# Access Compliance Report

## Public Rights-of-Way

### (Curb Ramps)

Intersection ID: 48198	Main Street: RIVERGATE_PY	Cross Street: S_TRYON_ST	Location: SW
ADA ID: C7D2EEB1924C	Ramp Type: Perp	Initial Pass/Fail: Fail	Overall Compliance: No
Codes/Mitigation Info/Possible Solution			Severity Score: 10
			Field Measurements/Component Compliance

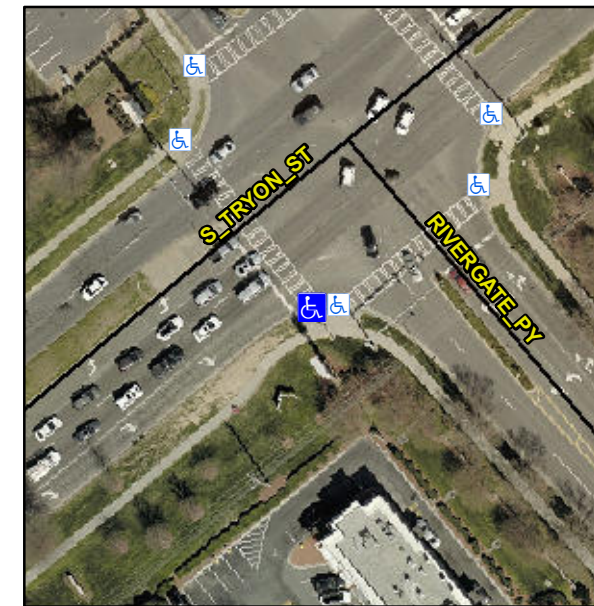
**Not Found, R304.5.1**

Compliance	Description	Data	Compliance	Description	Data
N/A	Ramp Length (in)	98.0	Yes	Ramp Slope (%)	6.2
No	Ramp Width (in)	47.0	Yes	Ramp XSlope (%)	4.1
N/A	Flare Type LT	N/A	N/A	Flare Type RT	N/A
N/A	Flare Slope LT (%)	N/A	N/A	Flare Slope RT (%)	N/A
N/A	Flare Traversable LT?	N/A	N/A	Flare Traversable RT?	N/A
N/A	Landing Length (in)	N/A	N/A	DWS Provided?	N/A
N/A	Landing Width (in)	N/A	N/A	DWS Contrast?	N/A
N/A	Landing Slope (%)	N/A	N/A	DWS Length (in)	N/A
N/A	Landing X Slope (%)	N/A	N/A	DWS Full Width?	N/A
N/A	Landing Curb? (Y/N)	N/A	N/A	DWS Offset (in)	N/A
N/A	Shared Landing?	N/A			
N/A	Gutter Ponding?	N/A	N/A	Gutter Slope (%)	N/A
N/A	Gutter Lip Ht (in)	N/A	N/A	Gutter X Slope (%)	N/A
N/A	Painted X Walk1?	Yes	N/A	Painted X Walk2?	N/A
	X Walk 1 Direction	To NW		X Walk 2 Direction	N/A
N/A	X Walk 1 Width (in)	105.0	N/A	X Walk 2 Width (in)	N/A
	X Walk 1 Slope (%)	3.2		X Walk 2 Slope (%)	N/A
	X Walk 1 X Slope (%)	4.1		X Walk 2 X Slope (%)	N/A

**Remove & Replace Entire Ramp.**
